September 1, 1961

Re: Inspection and Repairs to
Independence Hall Tower

REPAIRS TO
INDEPENDENCE HALL TOWER
S.S. OF CHESTNUT BET. 5th & 6th STS.
NATIONAL PARK SERVICE

SKETCH NO. 1
SCALE 1/4"=1'-0"

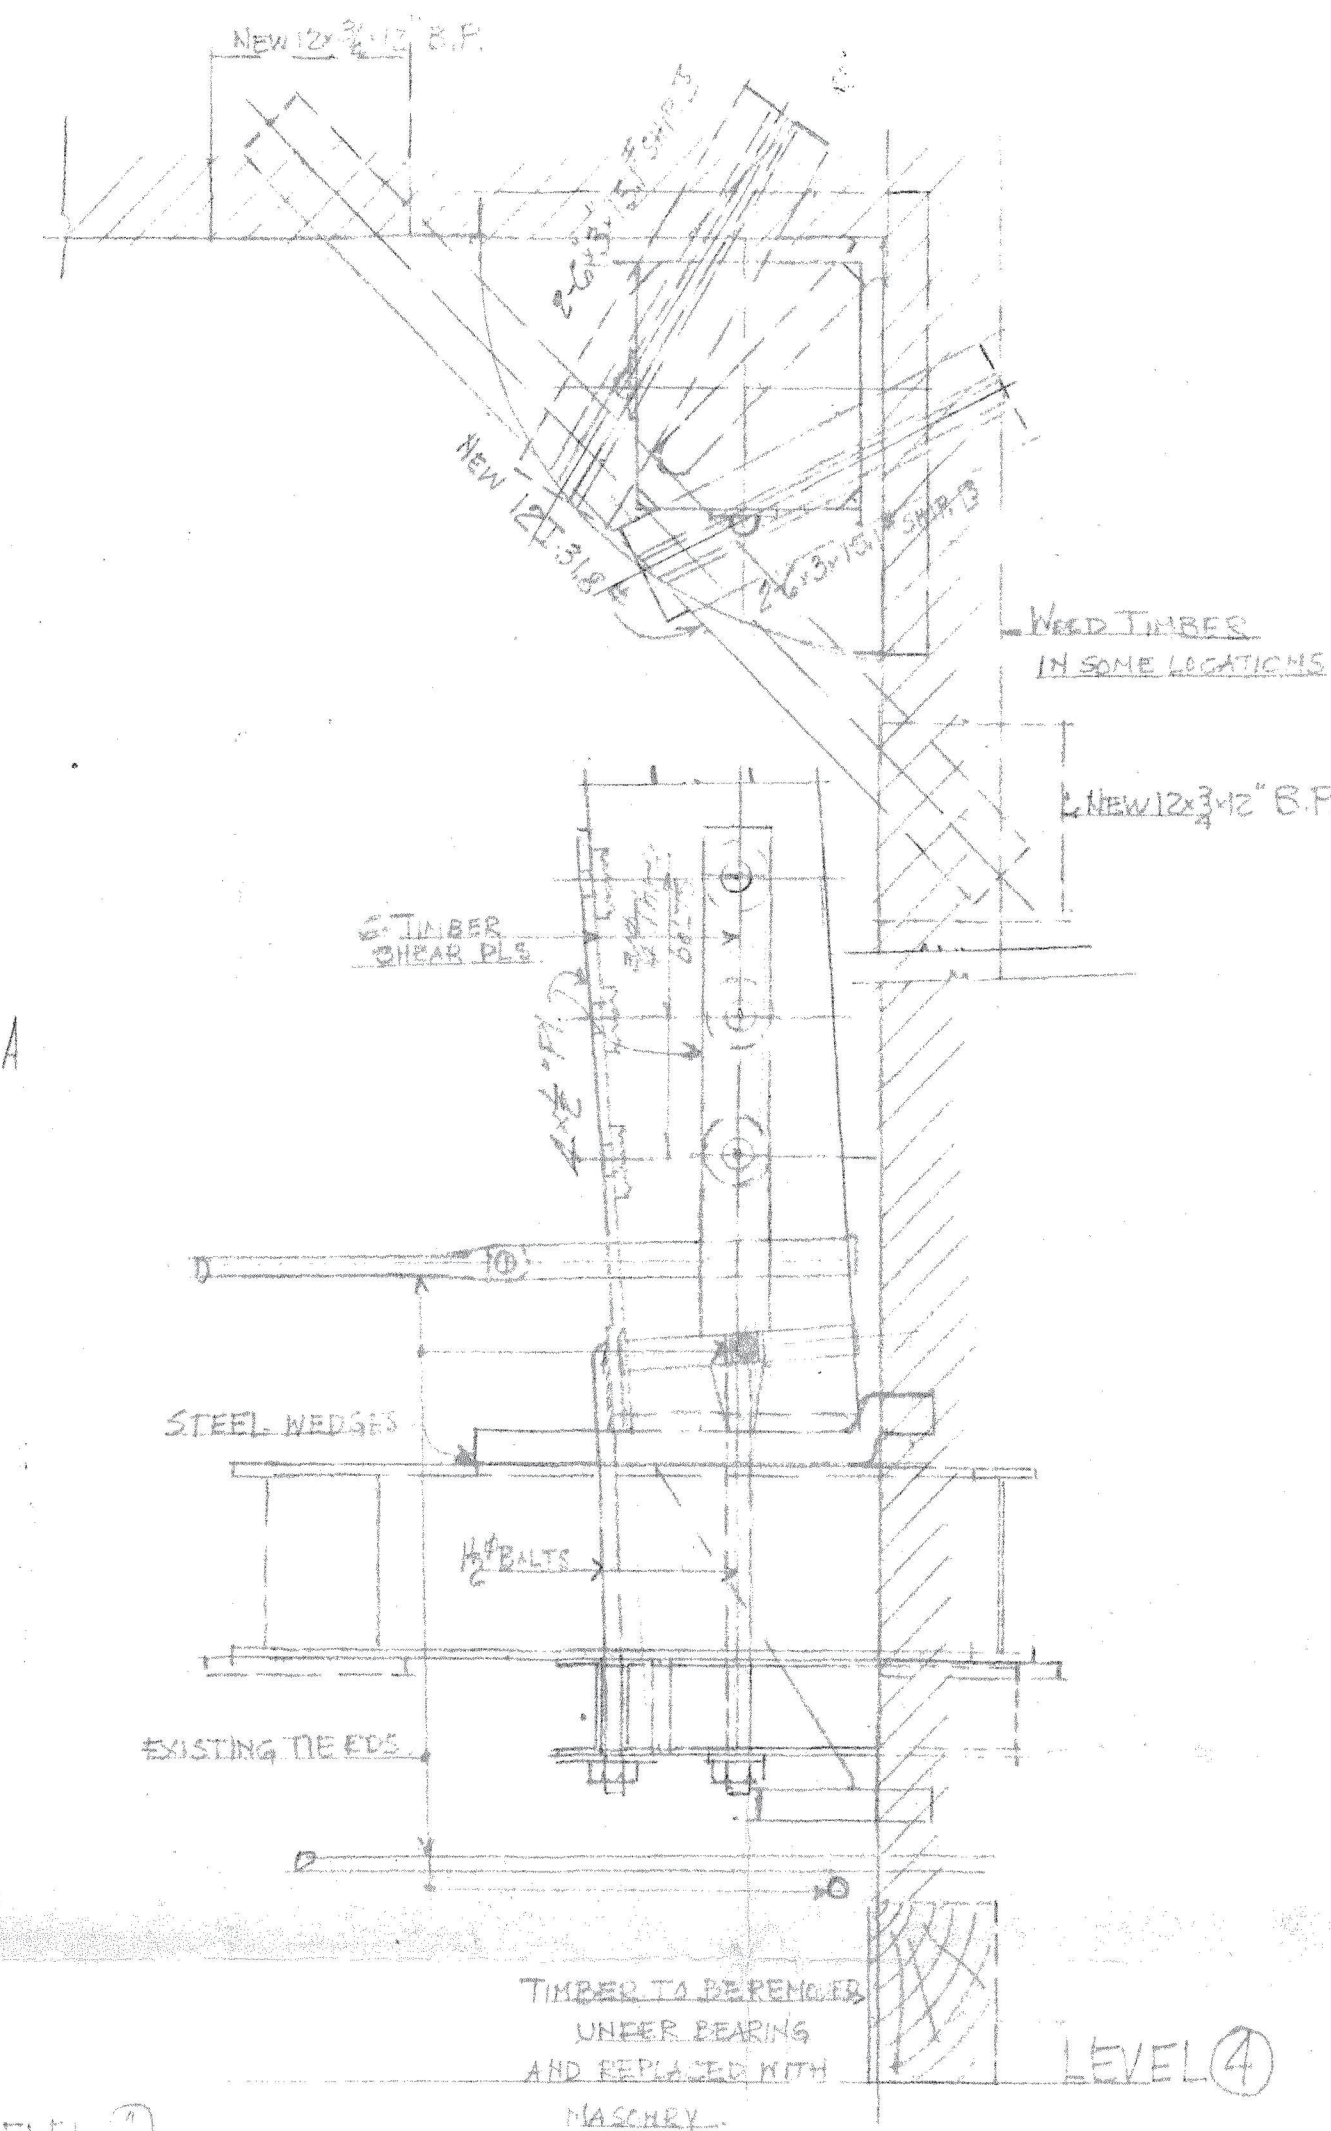
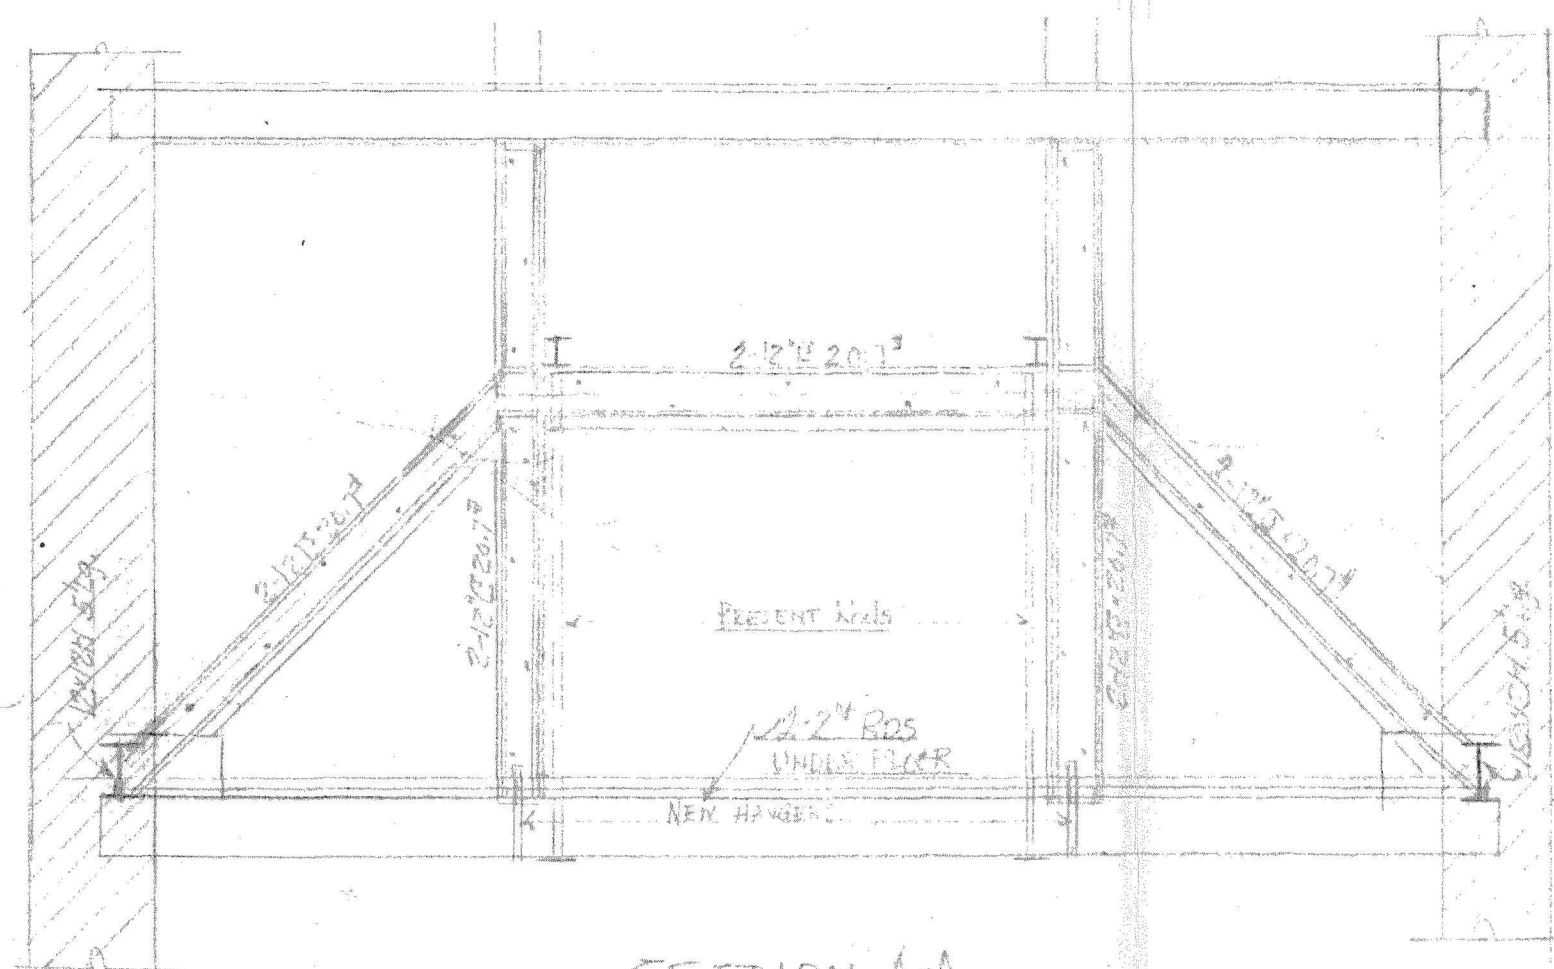
1. No. 5 Level: The two interior trusses running east and west to be reinforced with two channels—one on each side with two tie rods under the floor serving as the bottom tie. This truss, with its two vertical posts, will be made to support the fifth, fourth, and third levels and carry the weight of the clock mechanism. A detail of this is shown in Sketch No. 1.

SKETCH NO. 2
SCALE 1/2"=1'-0"

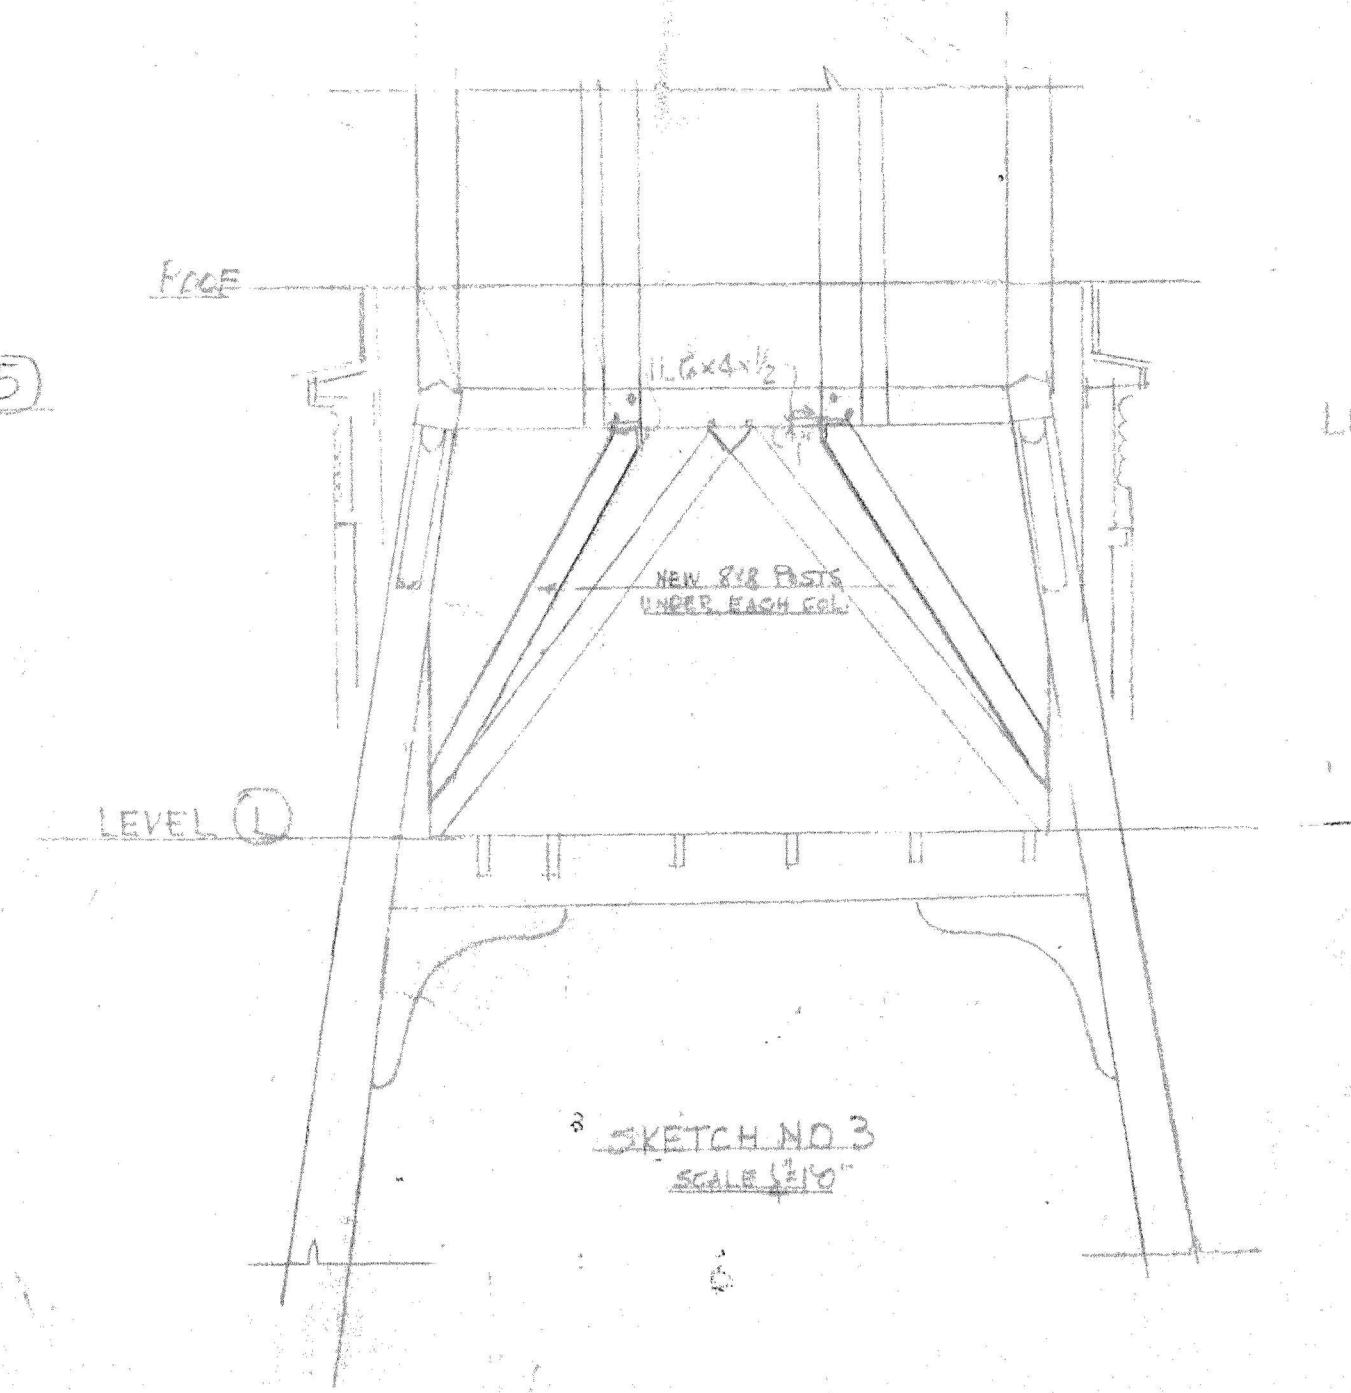
The bottom of the main tower supports is not fastened down at its bearing on the C.I. bracket. The only force holding the tower down against overturning is the weight of the frame tower, itself. According to my figures, this is inadequate to carry a 100 miles-per-hour wind load. The weight of the brickwork from the fourth to the third levels would add considerably to the dead load at each corner. I recommend that the weight of this brickwork be utilized to afford a sufficient factor of safety against overturning. This can be done by tying down the bottom of the four corner columns to its support, thus transferring the uplift to the brick walls. See Sketch No. 2.

SKETCH NO. 3
SCALE 1/2"=1'-0"

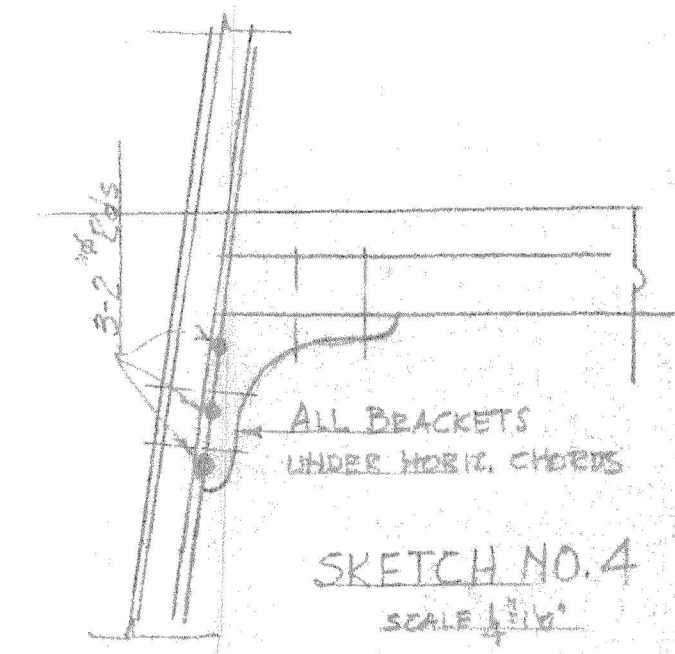
3. At the roof level, the eight posts carrying the bell are supported on timber trusses framing between the four inclined posts, or columns. The top chords of some of these trusses have sagged due to the fact that no vertical member occurs under these posts, thus throwing bending into the top chord. I recommend that an 8 x 8 diagonal running from this post to the heel of the truss be placed at each of these points to carry this load directly, as shown on Sketch No. 3.

SKETCH NO. 4
SCALE 1/2"=1'-0"

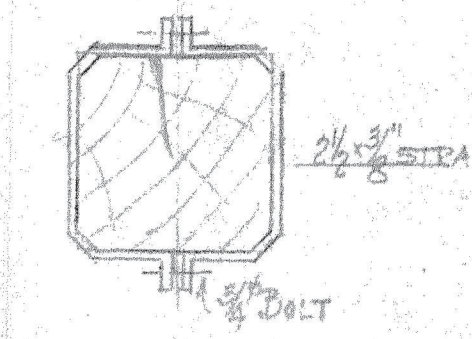
4. I can find no positive support of any of the framing into the four main column supports, other than bolts. I do not consider this adequate to carry the weight. I recommend that 3 - 2" rods be placed between the knee and inclined columns by drilling holes $1/16"$ less than the diameter of the rods and driving these rods to a tight fit, as shown in Sketch No. 4. These would be placed in the knee braces under the main carrying chords, only.

SKETCH NO. 5
SCALE 1/2"=1'-0"

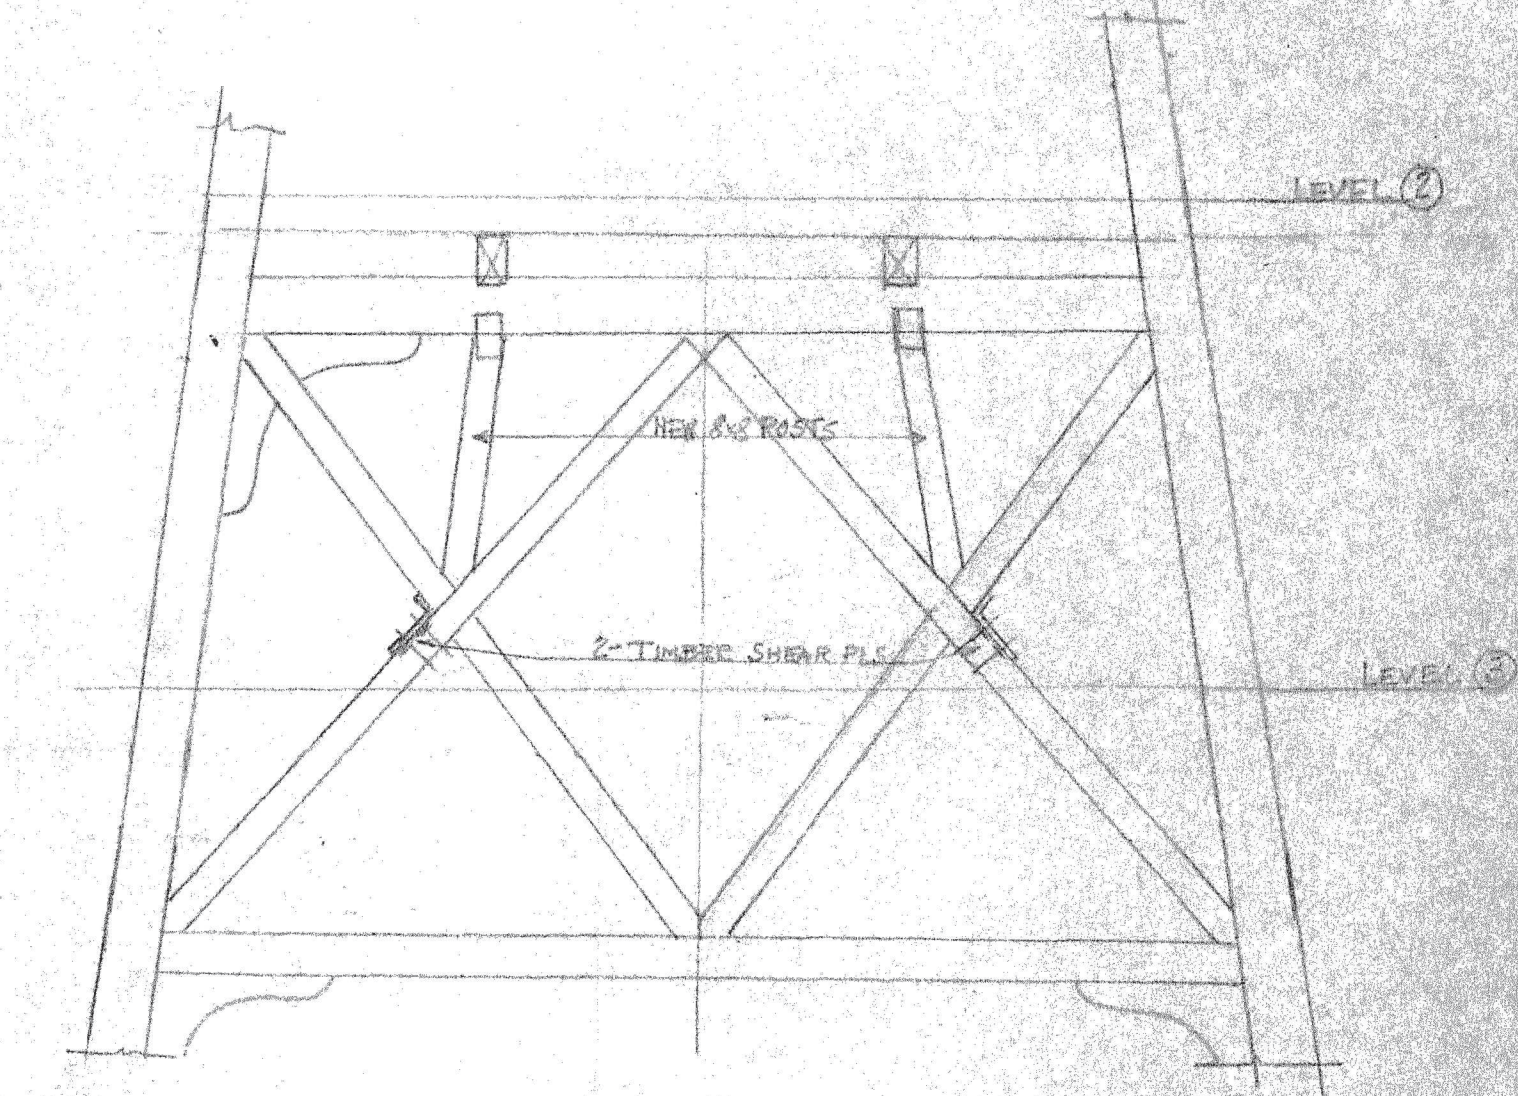
5. Some of the main column members have bad checks--some as much as $\frac{1}{2}"$ in width. These checks do not go completely through the members. I would reinforce these by using $2\frac{1}{2} \times 3/8$ bands spaced about 2' 0" o.c. where these checks occur. See Sketch No. 5.

SKETCH NO. 7
SCALE 1/2"=1'-0"

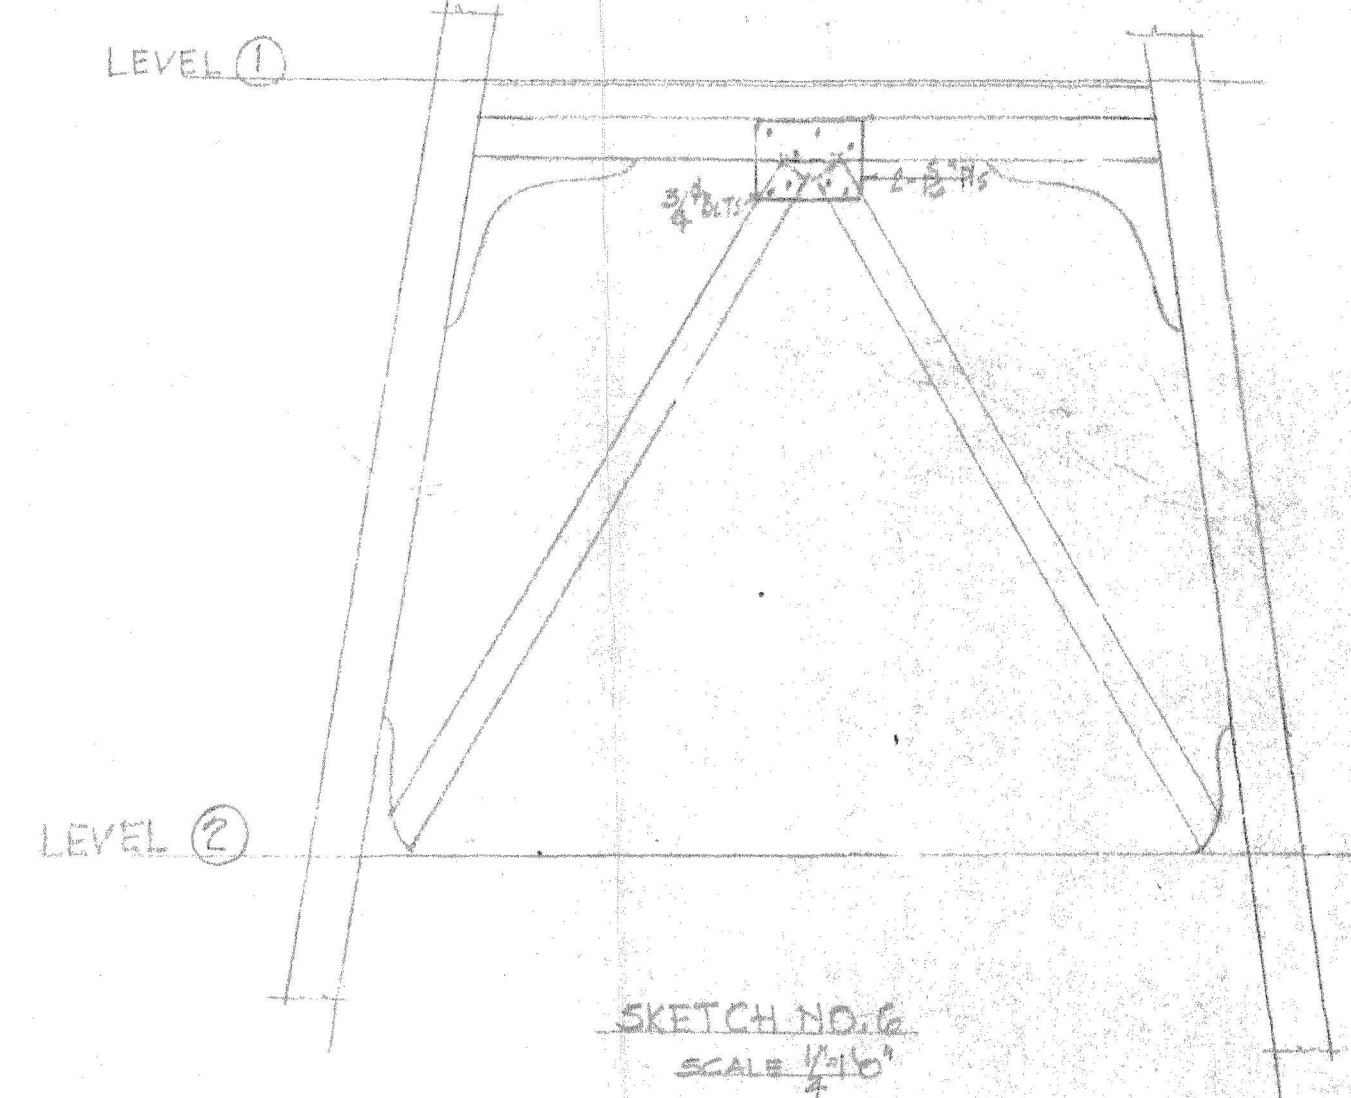
8. Two large floor girders $11\frac{1}{2} \times 14\frac{1}{2}$, running north and south and supporting Level No. 2, frame in the middle between panel points of the top chord of the supporting truss. While there is no definite deflection in the top chords, I recommend inclined 8 x 8's be placed under this chord and framing into the middle of the diagonals, as shown on Sketch No. 7.
